Ref. No. 201511026 Petition No. 883

PETITION NO. 883 DUCHARME PLACE, LLC. 25925 TELEGRAPH RD. SUITE 202 SOUTHFIELD, MICHIGAN 48033 C/O WALTER COHEN PHONE NO. 248 353-7981

REQUEST ENCROACHMENT INTO PUBLIC EASEMENT 33 FT. WD. AT 1544 - 1556 E. LAFAYETTE BLVD. (With Pedestrian Bridge and Secured Gate)

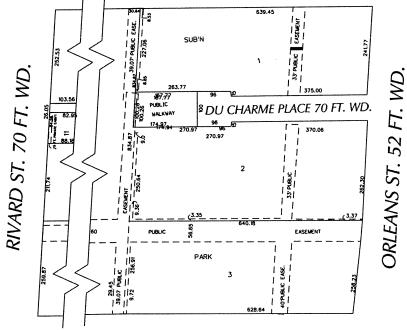
- () Not Involved.
- () Involved; but asking you to hold action on this petition until further notice.
- () Involved; the nature of our services, and the estimated costs of removing and/or rerouting such services are:
- Involved; have no objection to the requested encroachment into public easement 33 ft. wide at 1544-1556 E. Lafayette Blvd. (with pedestrian bridge and secured gate) as shown on drawing no. x883 dated 11/10/2015 provided that 100% signatures of abutting property owners are secured. As stated on the proposed plans, the pedestrian bridge shall have a minimum vertical underclearance of 13'6".
